## Responses to Questions

### Kappa Delta Renovations/Expansion

AG Architects Project No. 18-738.1

These are the questions received from Michael Behrendt, Town Planner, on 17 December 2018, along with our responses:

# Techo Bloc EVA

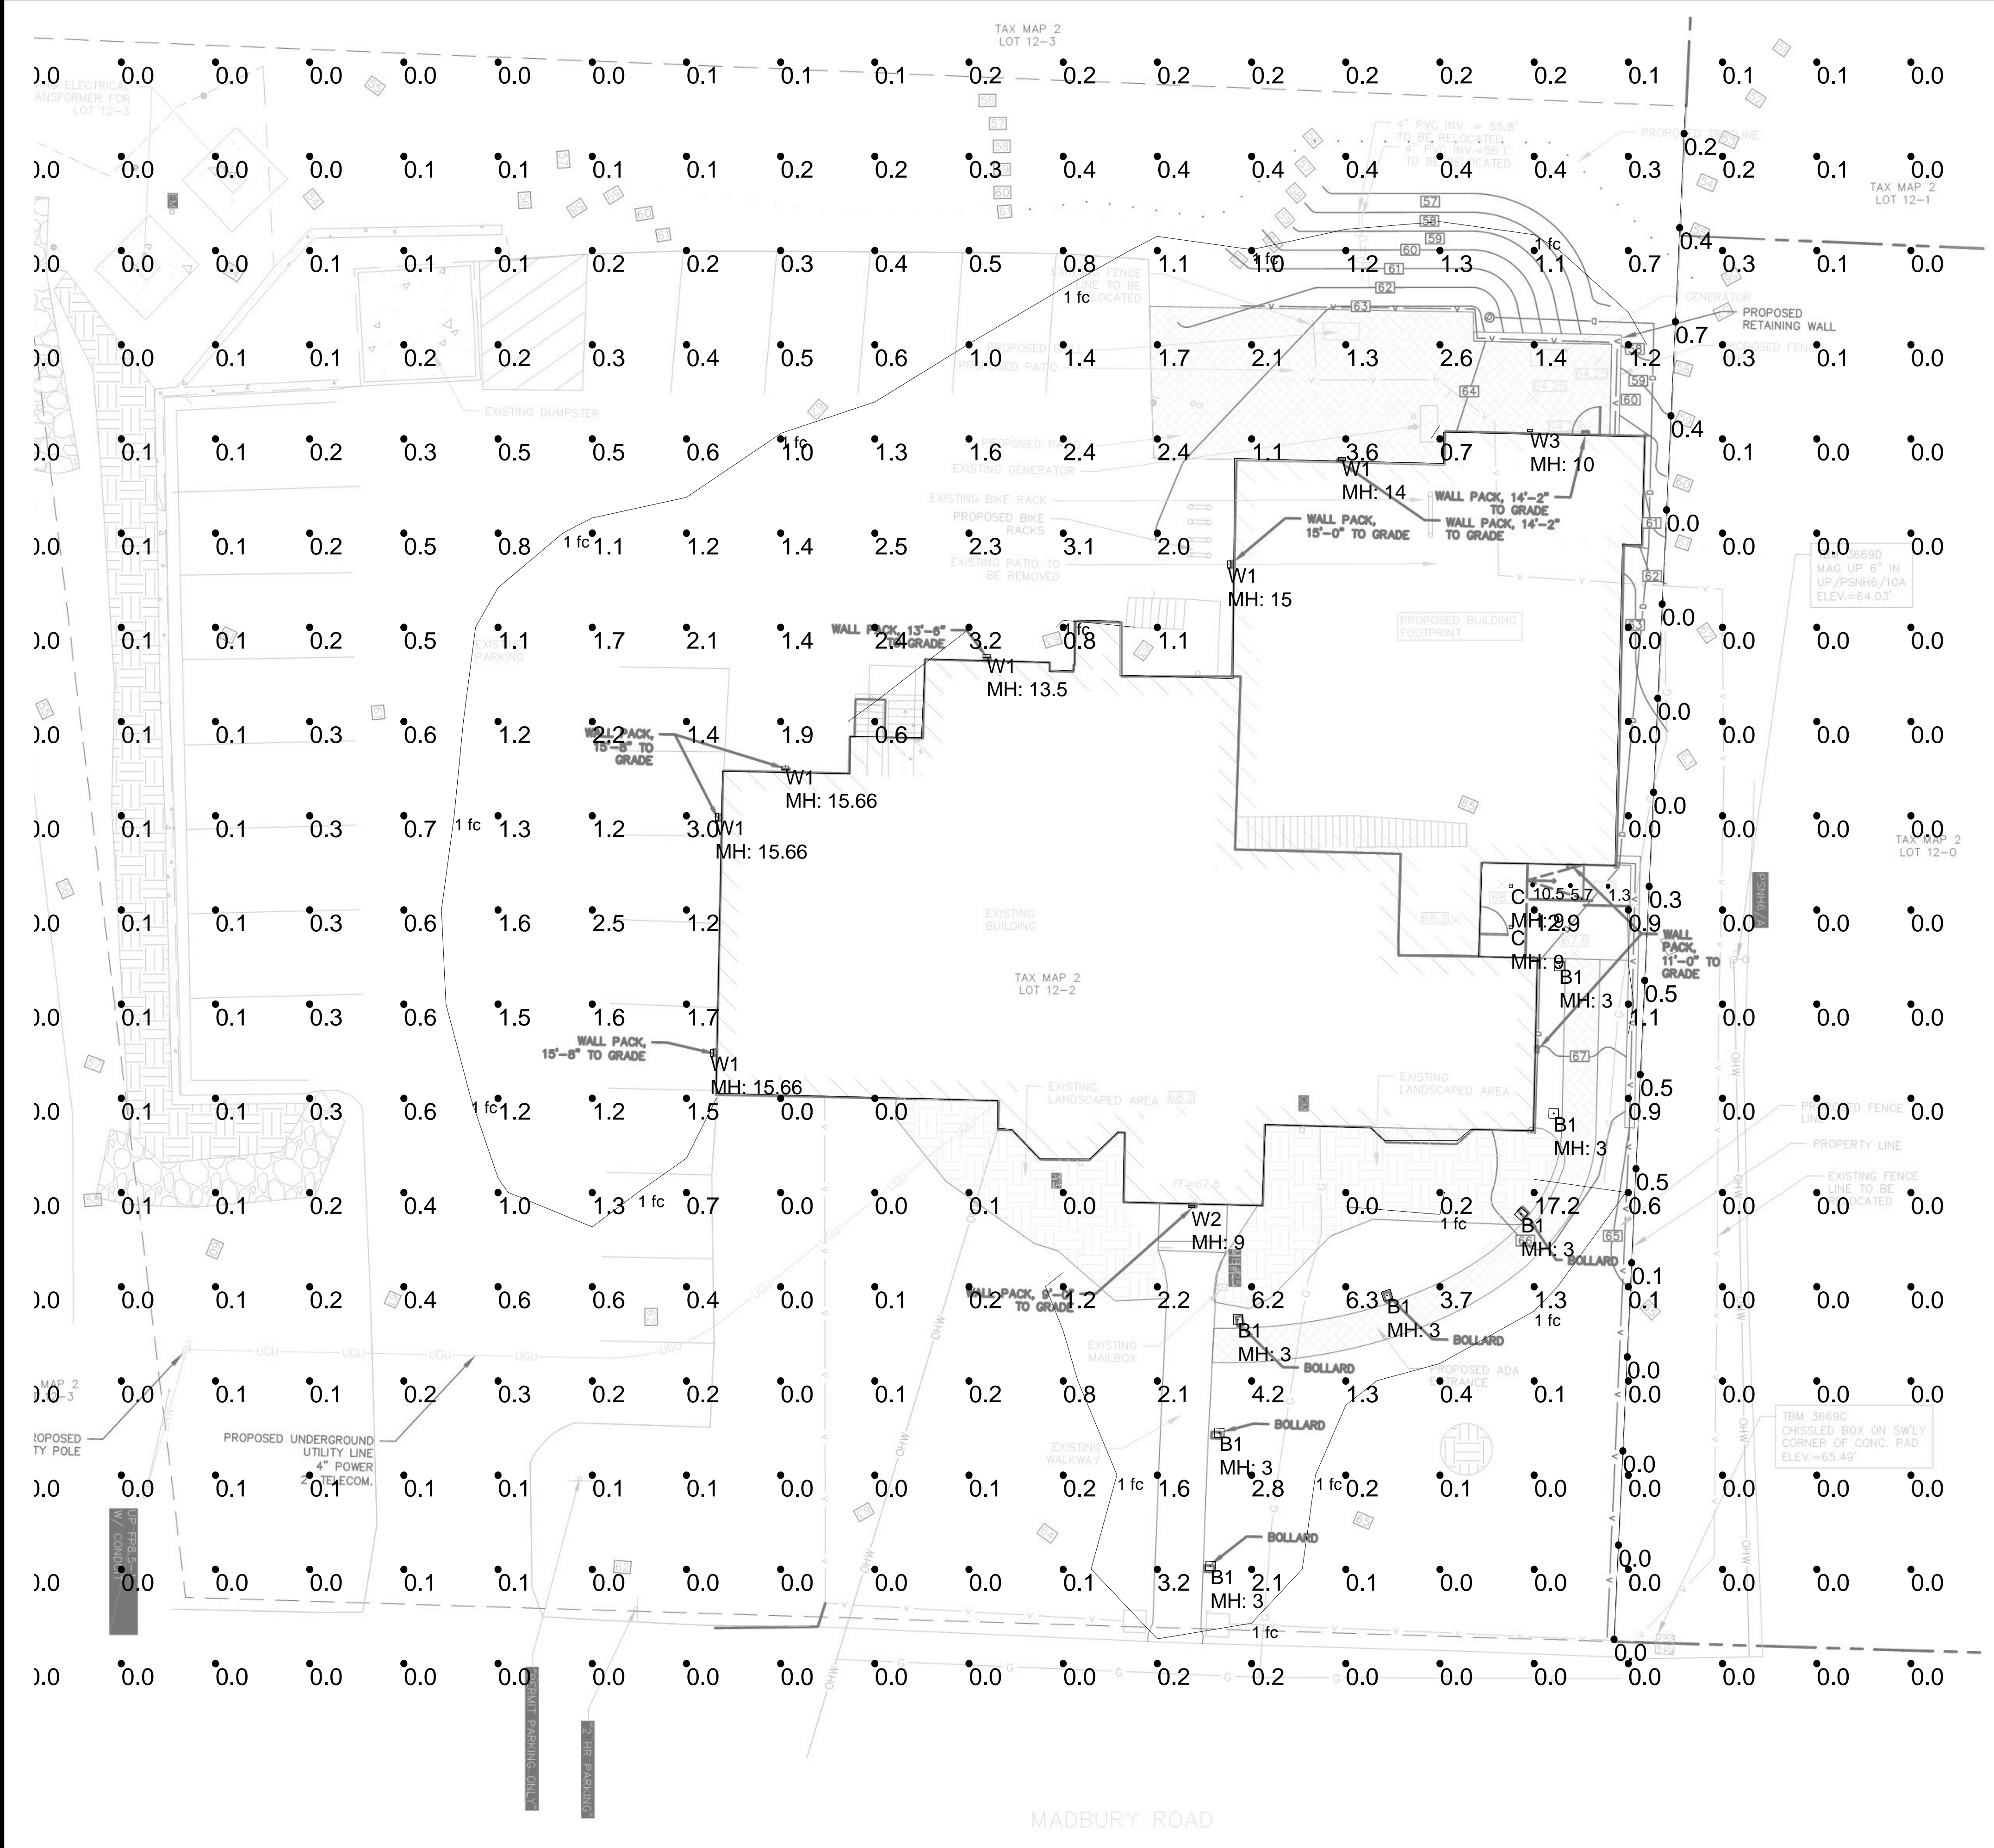
- 8) For the patio, do you have a sample of the stone pavers?

The pavers for the patio are planned to be Techo Bloc Eva Pavers, Champlain Grey. A catalog cut sheet is attached, and we will bring a sample to the Planning Board Public Hearing.

## Fixture B1

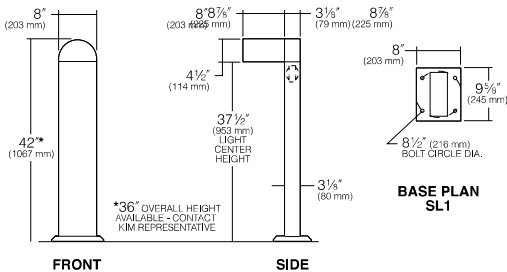
- 10) Please provide cut sheets of the lights – wall packs and bollard lights. The lighting regs set a maximum of .5 footcandles at a residential property line. Some areas are higher than that.

Cut sheets for site lights including the wall packs, bollards and entry soffit lights are attached and also included in the updated Civil Drawings. The lighting regulations set a maximum of 1 footcandle at non-residential property lines, which the adjacent Alpha Chi Omega sorority is. The updated Site Lighting Layout plan attached and included with the updated Civil drawings complies with the 1 footcandle limit.

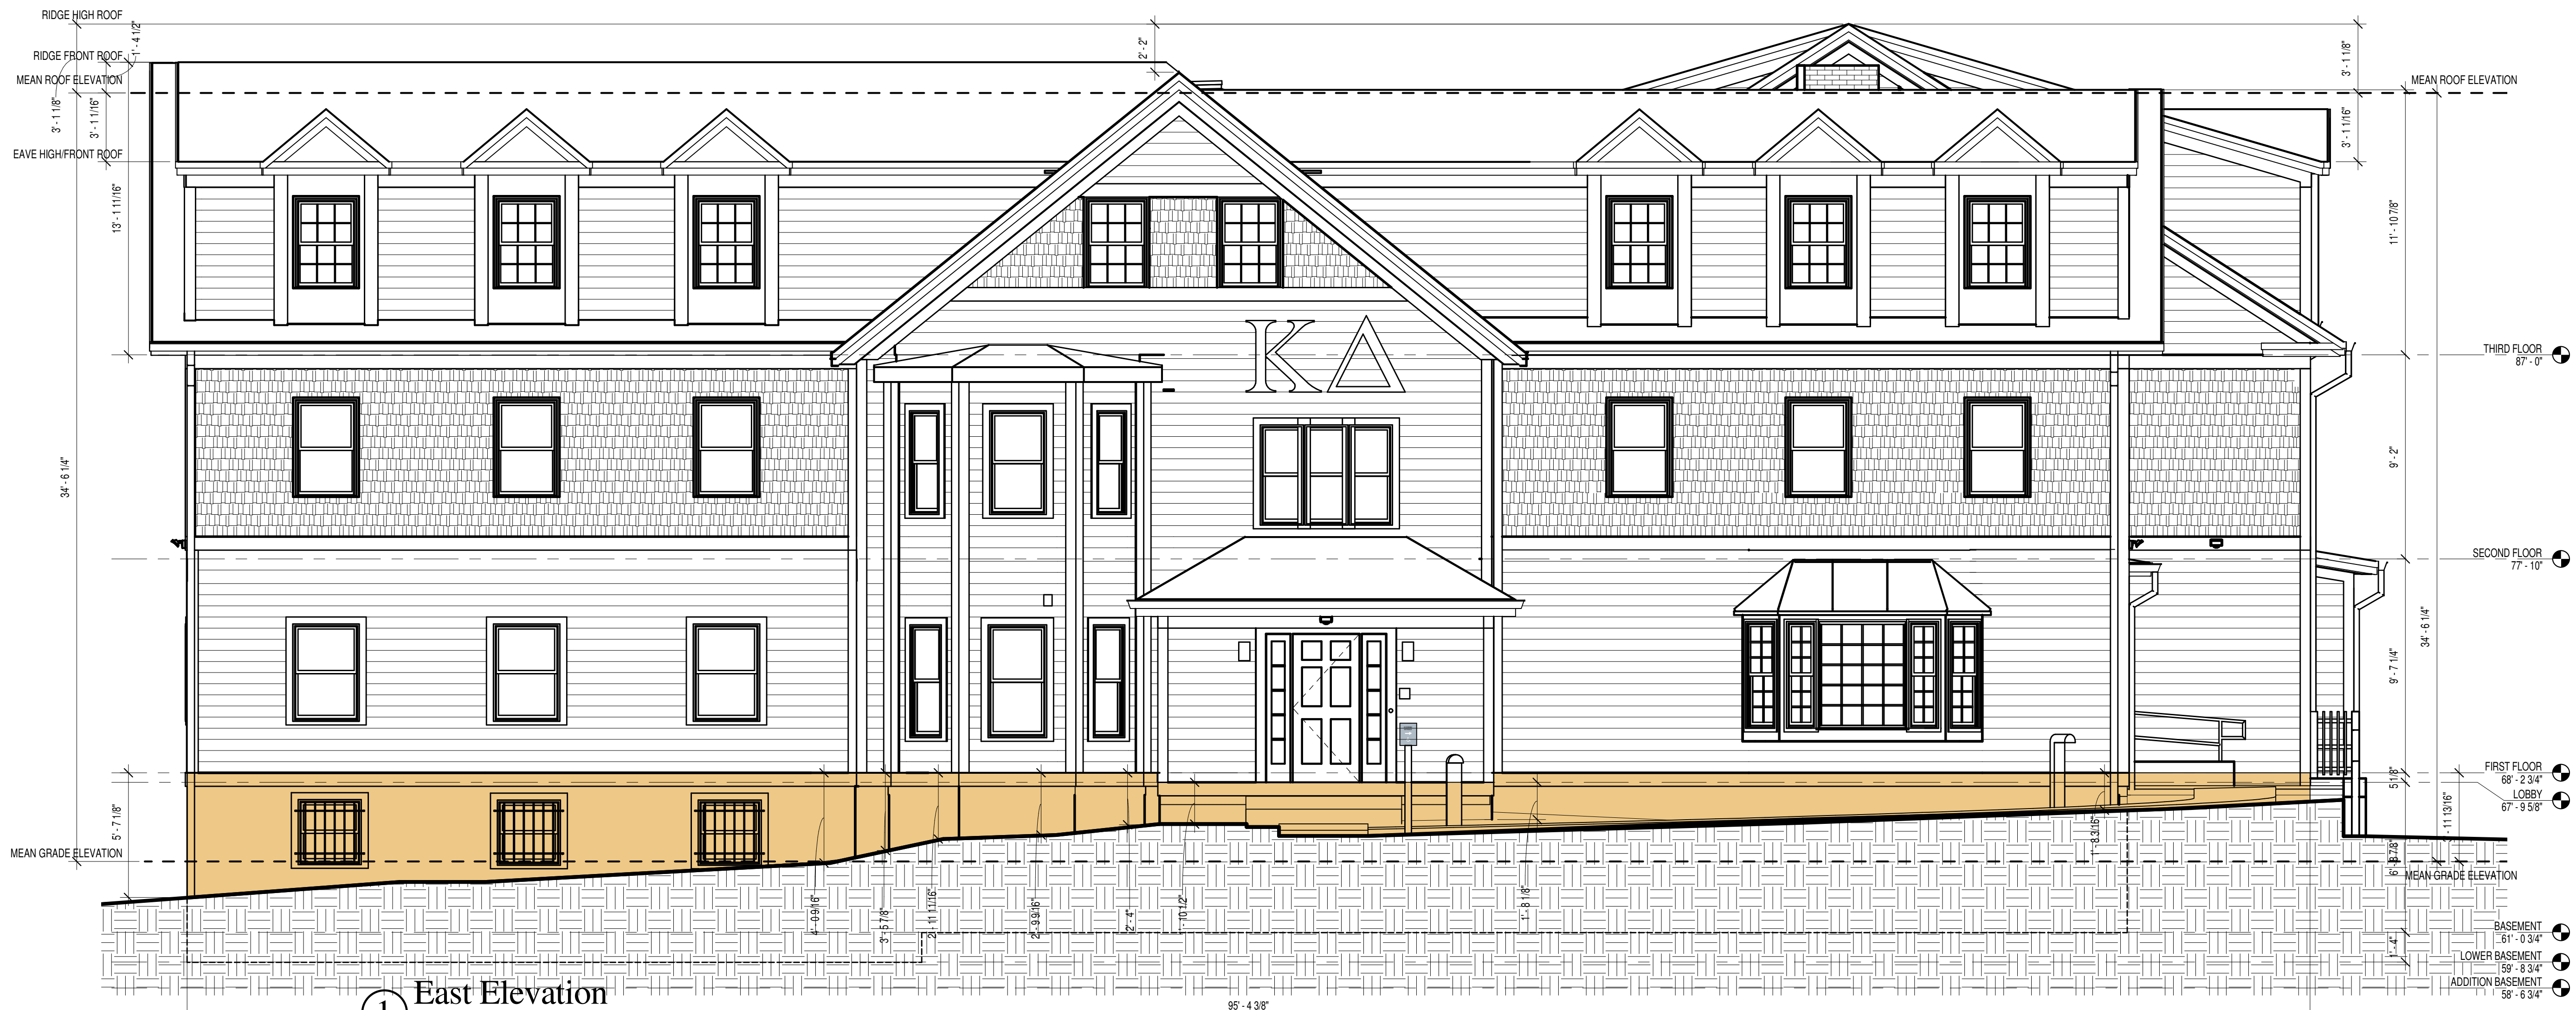
18) Art, please give an explanation for how you arrived at the height of the building, based on the definition.

The roof height for the Kappa Delta renovation/expansion project has been calculated based on the Town of Durham's Zoning requirements, including the definitions for Mean Roof Height and Mean Grade Elevation. The calculations were completed as follows:

**Roof:** Attached are Drawings A4.1 and A4.2 that include the four elevations for the proposed building. There are three different roof peaks for different wings of the building. We calculated the roof height based on the highest roof peak which is the new addition to the rear of the building (refer to West Elevation 2/A4.1 and North Elevation 1/A4.2). The other two roof peaks are lower, as seen in Elevation 1/A4.1, and would result in an overall lower roof height if these were used for the height calculation. The Mean Roof Elevation equals one half of the vertical distance from eave to ridge. West Elevation 2/A4.1 identifies the ridge and eave at the high roof, and the Mean Roof Elevation is shown at the mid-point between the ridge and eave.

**Grades:** The two Drawings A4.1 and A4.2 show the grades at the base of the building and the areas highlighted in orange are the distance from the first floor to the grade below. We calculated the Mean Grade Elevation by determining the area between the grade and first floor elevation for all sides of the building, added the areas of all four elevations together, and divided by the total perimeter length of the building. This establishes the average grade below the first floor. It is shown on Drawings A4.1 and A4.2 as the Mean Grade Elevation, which is 3' - 11 13/16" below the first floor.
